GXV3450/3470/3480 Firmware Release Notes

FIRMWARE VERSION 1.0.1.33

GXV3480, GXV3450, GXV3470

CONTROL SETTINGS BUTTON IN TASKBAR VIA API

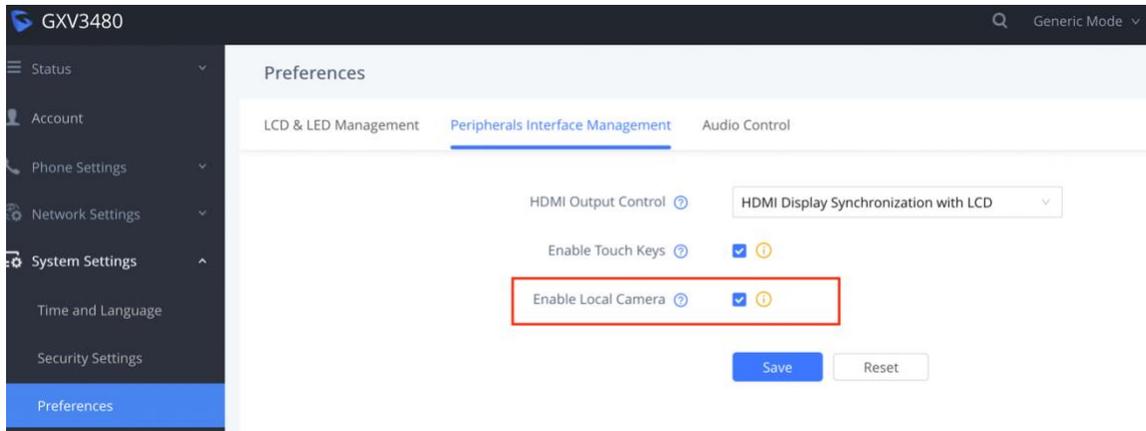
- Updated some Zoom modules.
- Added security enhancements.
- Supported web API which is the same as GXV33xx API set.
- Supported new hardware version.
- Added support to remove the Settings button in the Taskbar via API [CONTROL SETTINGS BUTTON IN TASKBAR VIA API]
- Added option to enable/disable local camera [ENABLE/DISABLE LOCAL CAMERA]
- Improved text display during video calls.

To control whether to display settings button on device taskbar, users could use below API commands to hide/display it and get the display status.

- Send broadcast to hide settings button:

- Send broadcast to display settings button:

```
Intent intent = new  
Intent("com.android.systemui.settings_button.visibility");  
intent.putExtra("visibility", true);  
sendBroadcast(intent);
```

ZOOM MODE

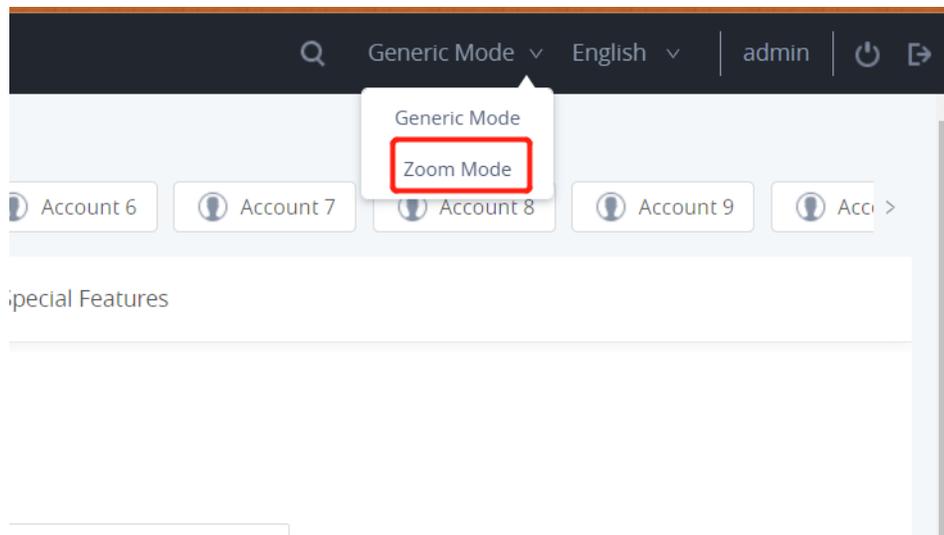
- Supported Zoom Mode. [ZOOM MODE]

The Zoom Mode is added to the web UI to integrate the device to Zoom app to the fullest. Switch to Zoom Mode from top right of web UI like below. The device will automatically start Zoom app. When enabled, only Zoom app runs on the phone.
